UNITED STATES PATENT AND TRADEMARK OFFICE

APPLICATION NO.	FILING DATE	FIRST NAMED INVENTOR	ATTORNEY DOCKET NO.	CONFIRMATION NO.
10/088,114	07/18/2002	Hiroshi Inoue	NIP-275	8078

Office Action Summary

DETAILED ACTION

FIG. 1

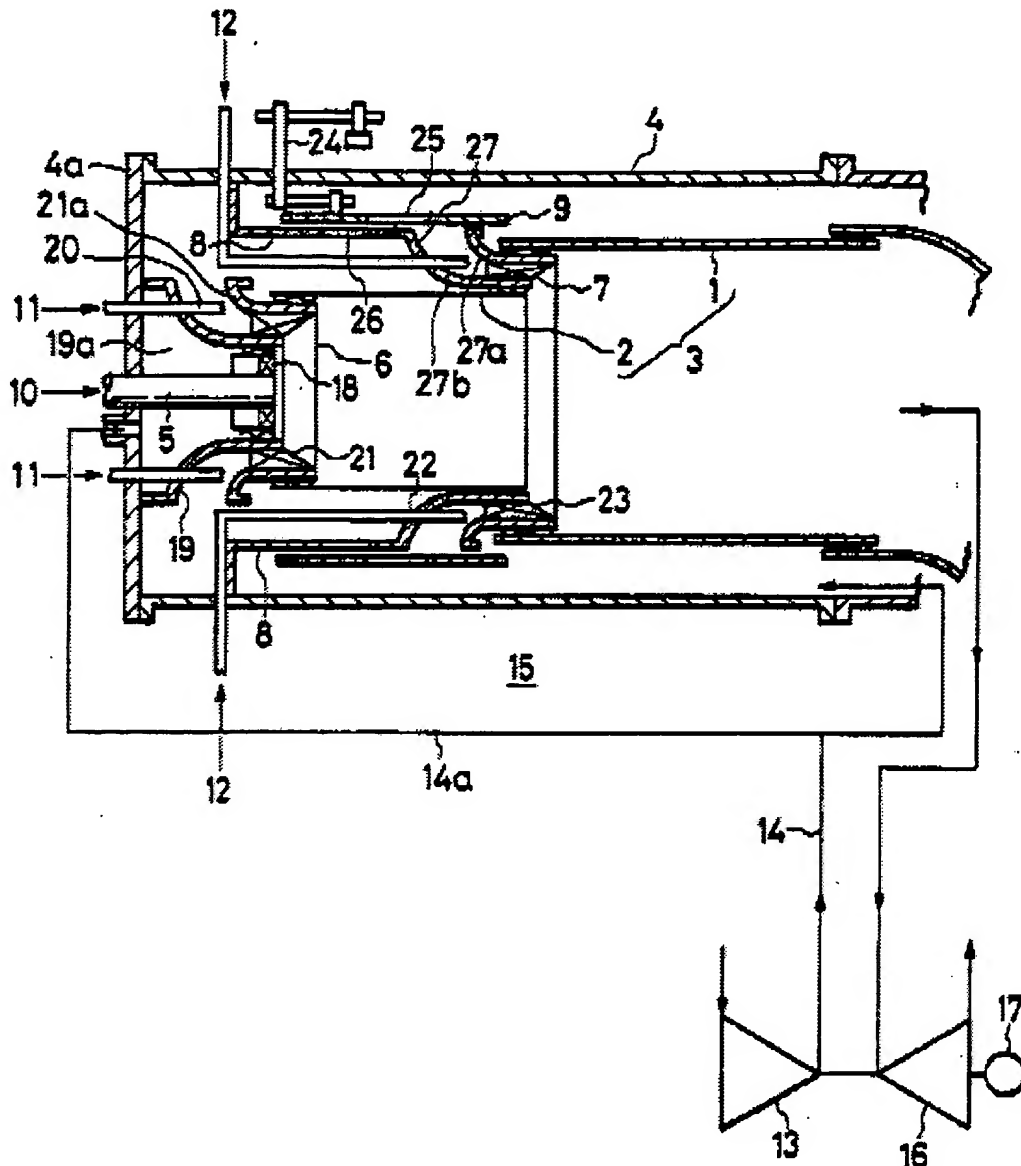
26. **Claims 1-3, 7, 9, 10 & 12-17** are rejected under 35 U.S.C. 102(b) as being anticipated by (5,069,029) to Kuroda et al.

Kuroda et al., Figure 1 as immediately displayed above discloses according to applicant's **claims 1-3, 7, 9, 10 & 12-17**, a gas turbine combustor (1) comprising diffusive combustion nozzles {inner ring of fuel fed nozzles (20)} which inject fuel and air into a combustion chamber (1) and form a diffusive combustion flame, outer and inner walls {framed by member (1), (2)-(9) & means for swirling (7)} which form an annular premixing flow passage {inline with (22)} and premixing nozzles (22) which are disposed in the premixing flow passage and form a premixing combustion flame by injecting premixed gas formed by premixing fuel and air into the combustion chamber (1) characterized in that a plurality of the premixing nozzles (22) are arranged in the premixing flow passage {inline with (22)} opening portions {between (2) & (27b), between (1) & (27b), between (8) & (9) and at (25)} permitting air to flow in are provided at the outer wall(s) {(9) and framed by (43)} so that the air flowed into the premixing flow passage forms swirling flow with respect to the premixing nozzles (22); and the opening portions {circumferentially framed volume sections between (27b) & (2), between (1) & (27b) and between (8) & (9) encompassing every two nozzles (22)} are disposed in circumferential

direction and are provided {at least} one for every adjacent two premixing nozzles (22) wherein the swirling flows at {(22) in (27b)} can rotate in directions opposite each other in the circumferential direction {especially during turbine gas flow transients like as during faulty starts or shutdowns} for every adjacent two premixing nozzles (22). See Kuroda et al., Figures 1 & 4 and respective portions, abstract, col. 3 lines 18-68, col. 4 lines 1-68 and col. 5 lines 1-9 of the detailed description.

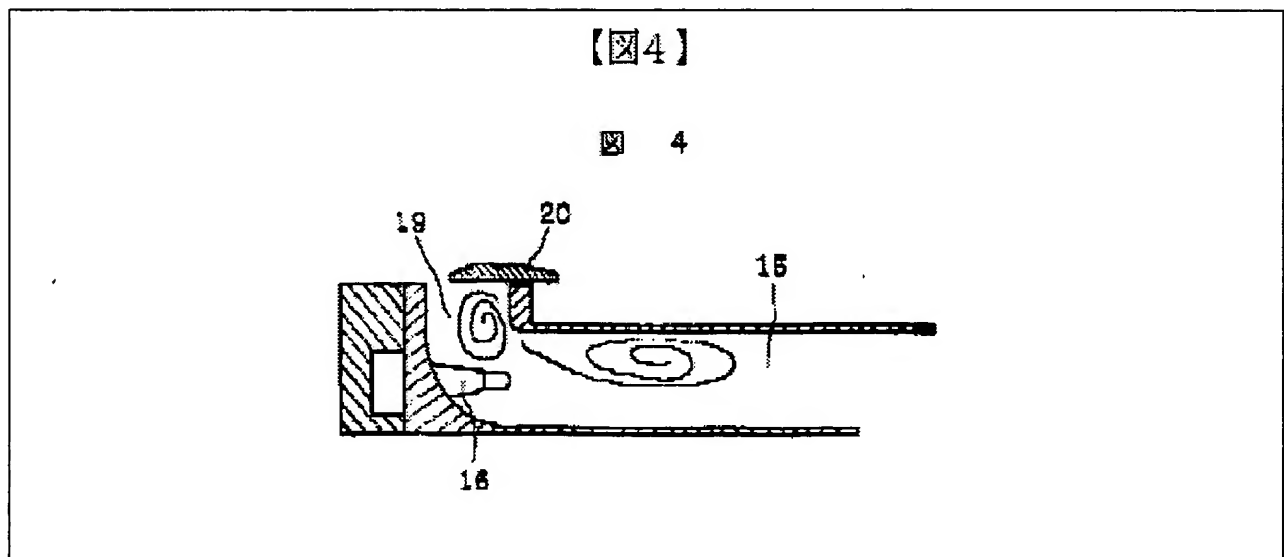
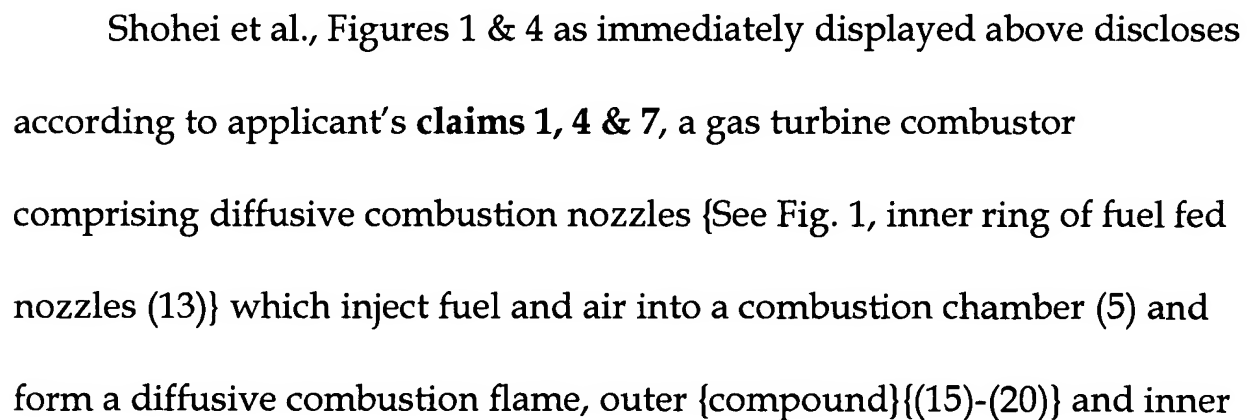
27. **Claims 1, 4 & 7** are rejected under 35 U.S.C. 102(b) as being anticipated by (JP-08135969) to Shohei et al.

{part of (15)} walls which form an annular premixing flow passage (15) and premixing nozzles (16) which are disposed in the premixing flow passage and form a premixing combustion flame by injecting premixed gas formed by premixing fuel and air into the combustion chamber (5), characterized in that a plurality of the premixing nozzles (16) are arranged in the premixing flow passage (15); opening portions (19) permitting air to flow in are provided at the outer {compound} wall {(15)-(20)} so that the air flowed into the premixing flow passage forms swirling flow with respect to the premixing nozzles (16); and the opening portions (20){circumferentially framed volume sections encompassing opening (20) and every two nozzles (32)} are disposed in circumferential direction and are provided one for every adjacent two premixing nozzles (16). See Shohei et al. Figures 1 & 4 and English abstract.
